**Amendments To The Drawings**

**REMARKS/ARGUMENTS**

Application Serial No. 10/500,452  
Reply to Office Action of August 8, 2005

FIG 6

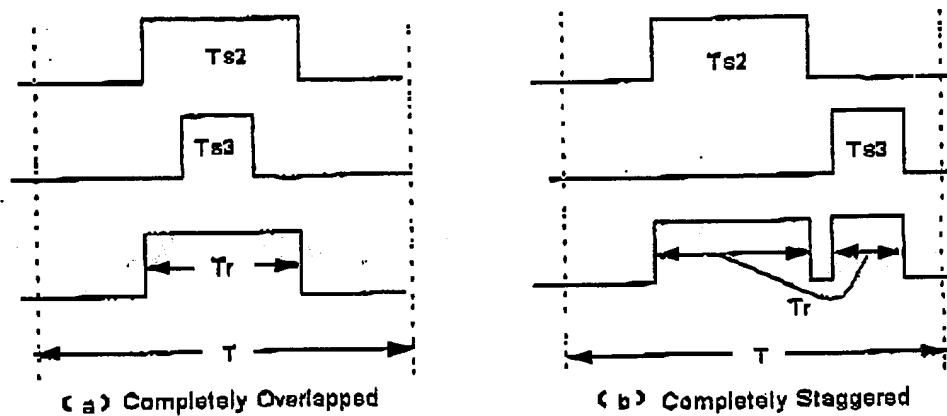
In the Office Action, the Examiner objected to the drawings as not showing every feature of the invention specified in the claims. In particular, the Examiner contends that the figures as filed do not show: the host identifying pulse width  $T_s$ ; the host releasing pulse width  $T_w$  and the feedback pulse width  $T_r$ , which are recited in claims 1, 3, 6 and 9. The Examiner also contends that the figures do not show a logic OR bus or a simple AND bus.

The two (2) attached drawing sheets provide a revised FIG. 6.

A revised FIG. 6 is submitted with depicts  $T_r$ . No new matter is added because  $T_r$  is fully described in the specification text. As for showing  $T_s$ , various instances of  $T_s$  are shown in FIG. 6 as filed. In particular,  $T_{s2}$  and  $T_{s3}$  are clearly shown in FIG. 6.
